## SECTION 009113 – ADDENDUM TWO

- A. Project Name: 21039.01 – Scott County School District ESSER 3
- B. Owner: Scott County School District
- C. Architect: Dale | Bailey, an Association
- D. Architect Project Number: 21039.01
- E. Date of Addendum Two: 1 November 2022

**Bettye Mae Jack - New Work Overall Mechanical Plan**  
 1 M-001a 1" = 20'-0"

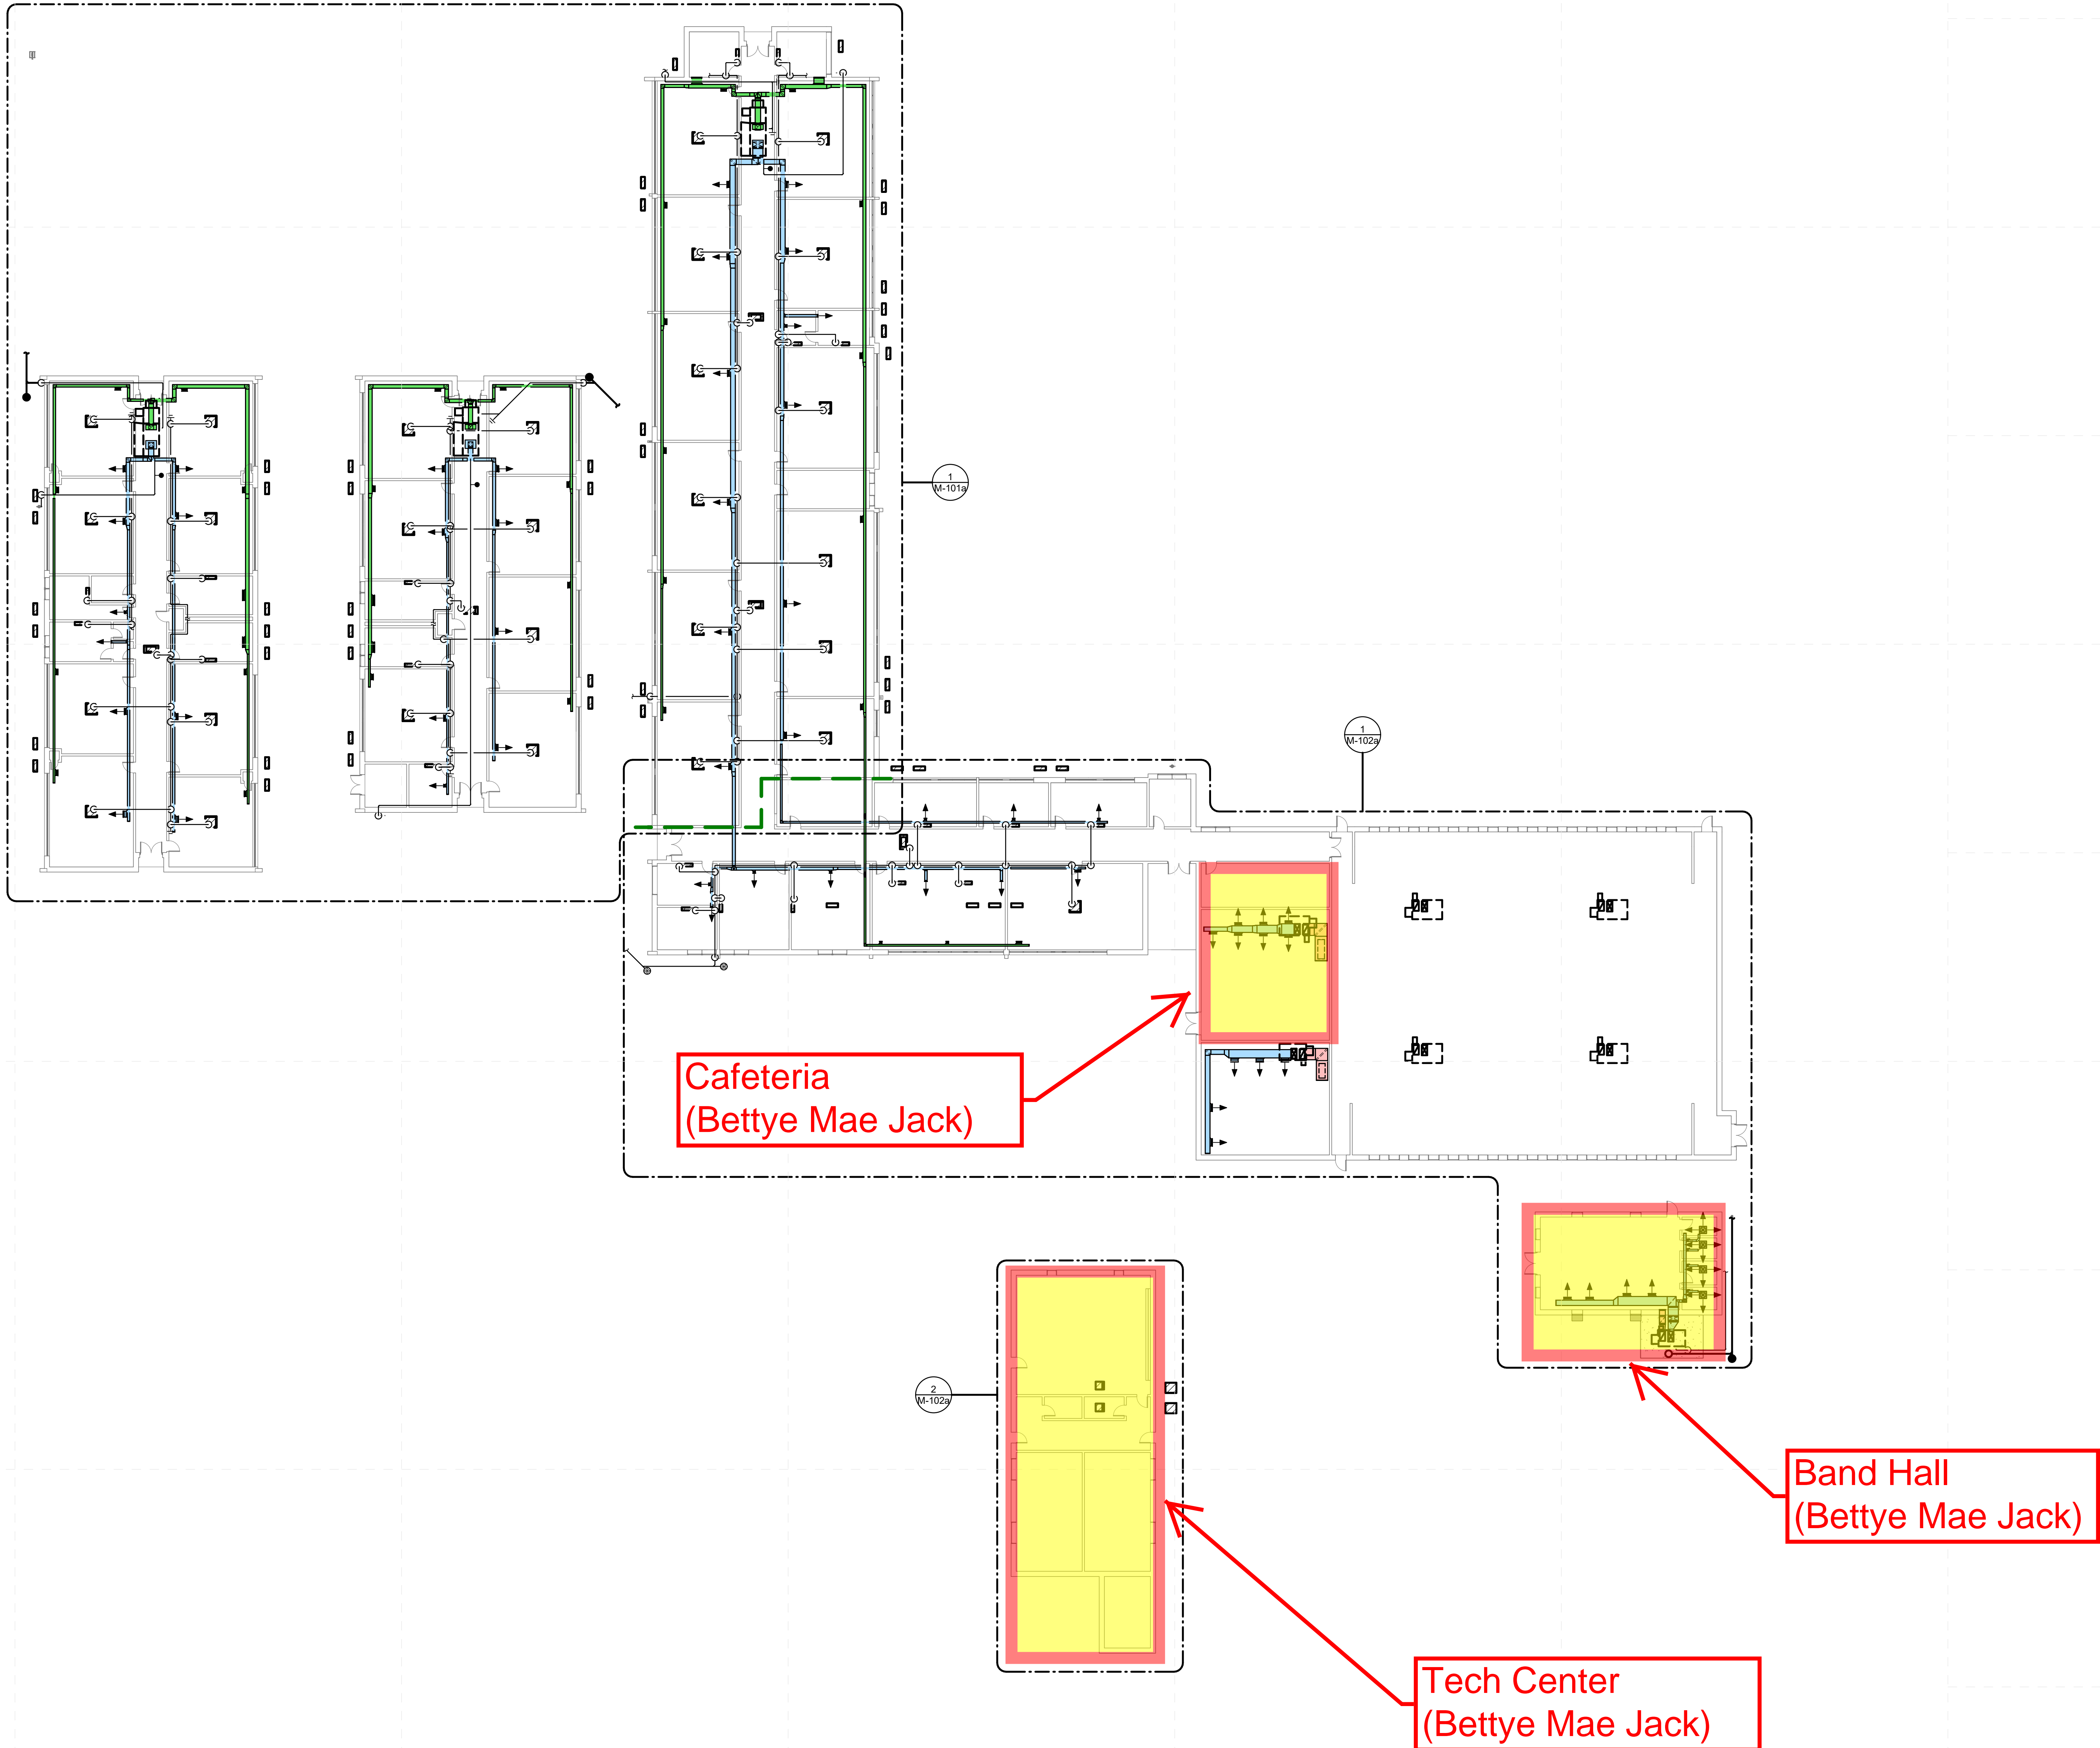
- A. Mechanical Sheet M-001a – BETTYE MAE JACK – OVERALL NEW WORK MECHANICAL PLAN. Delete the sheet in its entirety and replace with the attached. Added space identifiers to correspond with bid form.
- B. Mechanical Sheet M-001b – MORTON HIGH SCHOOL – OVERALL NEW WORK MECHANICAL PLAN. Delete the sheet in its entirety and replace with the attached. Added space identifiers to correspond with bid form.
- C. Mechanical Sheet M-201 – MECHANICAL SCHEDULES. (Not Re-Issued). Heat Recover Unit Schedule. Change HRU-M-01 electrical service to 240V., 3 phase.
- D. Mechanical Sheet M-201 – MECHANICAL SCHEDULES. (Not Re-Issued). Self-Contained Packaged Unit Schedule. Change AC-M-01 and AC-M-01 electrical service to 240V., 3 phase.
